NPA SITE PLAN
(2017-03)

INITIAL APPEARANCE
COMMERCIAL SITE PLAN

**TOWN OF NEWBURGH
PLANNING BOARD
TECHNICAL REVIEW COMMENTS**

PROJECT: NPA SITE PLAN
PROJECT NO.: 17-03
PROJECT LOCATION: SECTION 89, BLOCK 1, LOT 80.2 & 80.1
REVIEW DATE: 14 JULY 2017
MEETING DATE: 20 JULY 2017
PROJECT REPRESENTATIVE: ZEN DESIGN CONSULTANTS

PROPOSED SITE PLAN
 NEWBURGH PARK ASSOCIATES, INC.
 EXISTING SITE PLAN
 SEL. 89-1-19.22
 TOWN OF NEWBURGH, ORANGE COUNTY, NY

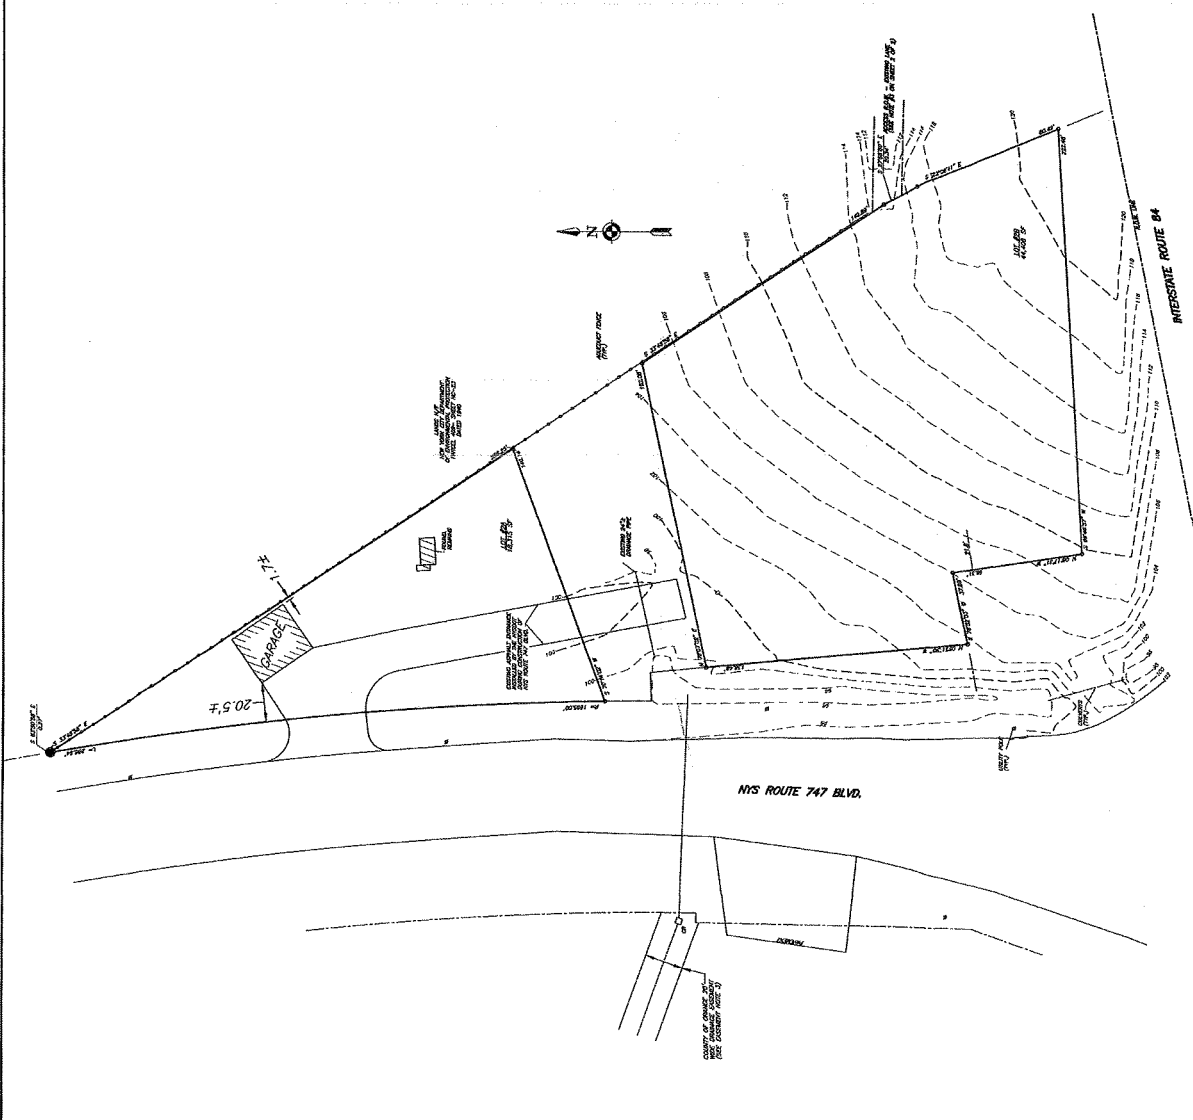
1. Bulk Table for the IB zone appearing on Sheet 1 of 2 should be corrected for IB District Schedule 8D(2) set back requirements.

2. Plans should clearly label each of the lots referred to on notes 1-3 of sheet 1 of 2. Lots 2a, 2b and 2 are referenced, however lots 2a and 2b are labeled.

This has been corrected on the plans.

I have attached a copy of the previous subdivision map which should help to clarify these notes.

ENGINEER WILLIAM J. MORSEAU	PROPOSED SITE PLAN NEWBURGH PARK ASSOCIATES, INC. PROPOSED SITE PLAN SBL: 89-1-19.82 TOWN OF NEWBURGH, ORANGE COUNTY, NY
DATE: 7/7/2016	SCALE: 1"=30'
PROJECT NUMBER: 15-002-AMU	SHEET NUMBER: 2 OF 2

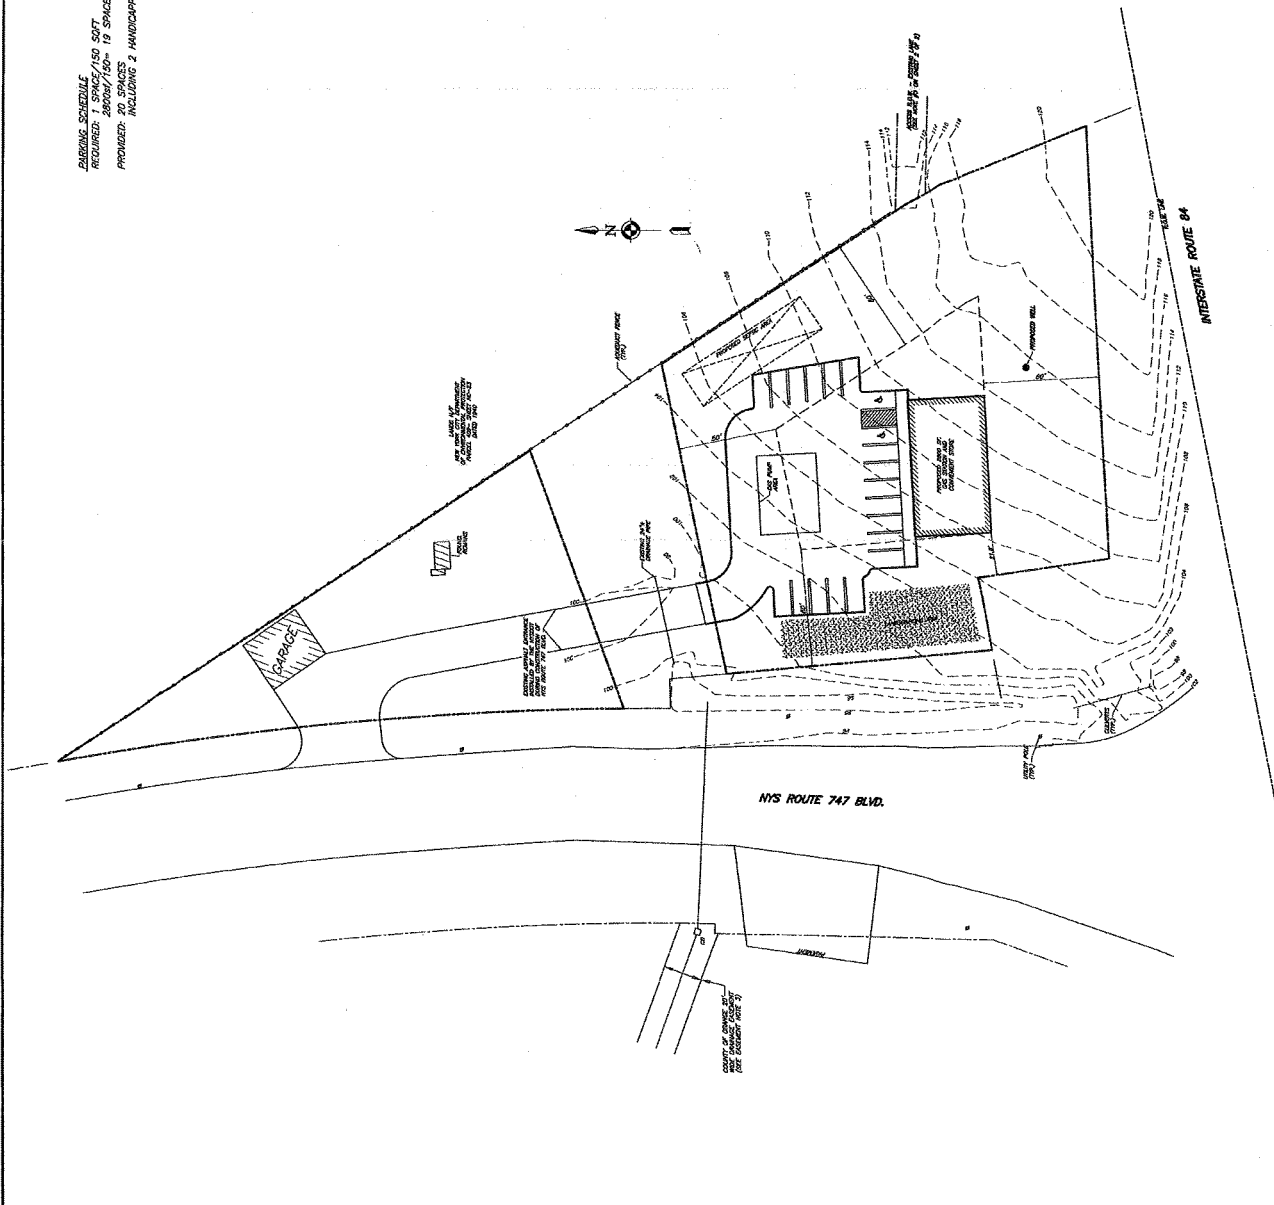
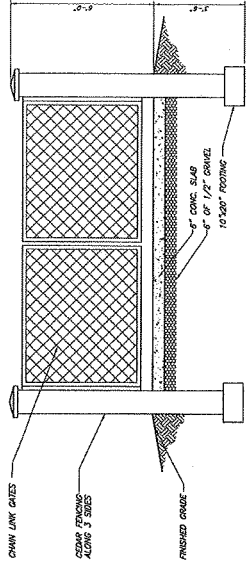
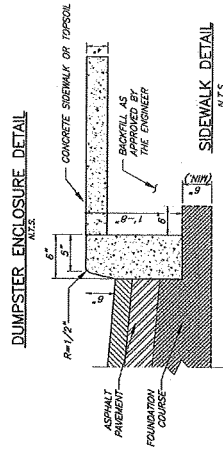
4. Plans should identify the point of access to the proposed development. Currently plans stop short of depicting access onto the State Highway. Bulk tables should include all minimum and maximum required items in Schedule 8.

5. The lot is considered a corner lot in accordance with Section 185-17. Both street frontages are front yards while one of the other shall be deemed a rear yard and side yard. These should be clearly labeled with dimensions.

9. The gas canopy extends into one of the set back.

11. The design guidelines should be considered when placing the structures and parking. Parking within the front yard set back would require a waiver from the Planning Board.

Access point onto 747 Blvd has been added to the plans. Bulk tables have been adjusted to show all requirements.

This has been adjusted on the plans.

This is the plan and will require a variance for this.

This is a very restricted site with a lot of limitations. The only available native soils to use for the septic are in the rear of the parcel. This is the only area that during the construction of the interchange was not regraded with new compacted materials. So we have shown the parking on the northern side of the building.
